**Land to the west of Chilgrove Drive, North of
Camp Road and adjoining former RAF Upper
Heyford, Upper Heyford incorporating former
MoD gymnasium: Planning Application
reference 14/02025/HYBRID**
Supplementary Transport Assessment

1 April 2015
Final Report
PB2420

Application no: 14/02025/HYBRID

Figure: **6B**

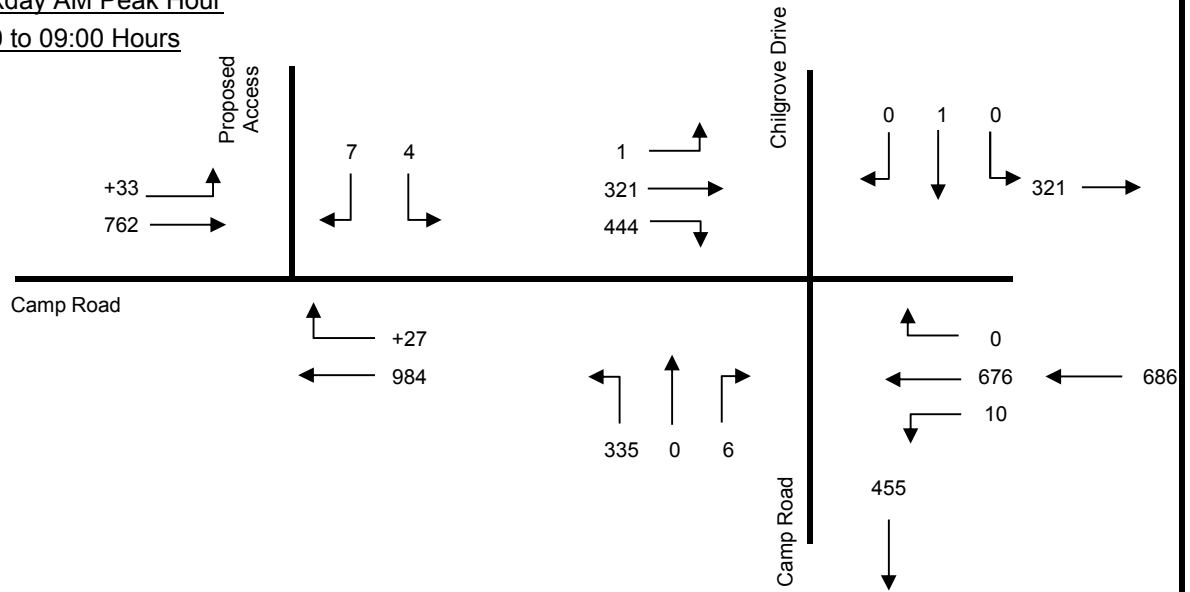
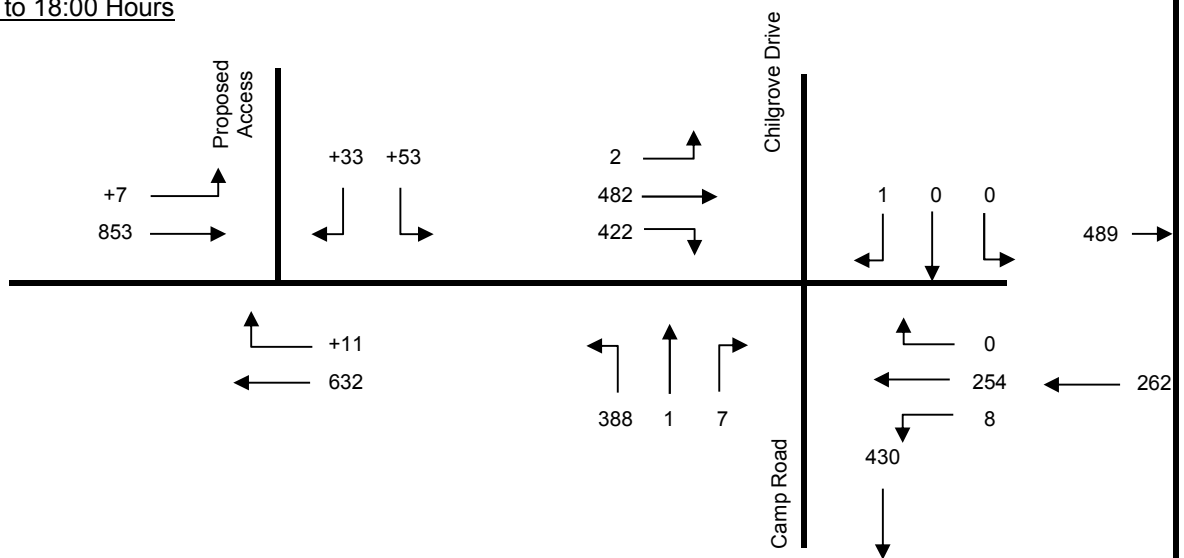
4.1.2 Provided at Appendix F (shown on Figure 6B) are details of the traffic flows used for analysis. These include the following: -

- Worst case traffic attraction associated with development proposals
- Committed Development associated with Heyford Park.
- Background growth up to 2019.

4.1.3 Consequently, the traffic figures provided at Appendix F are considered robust.
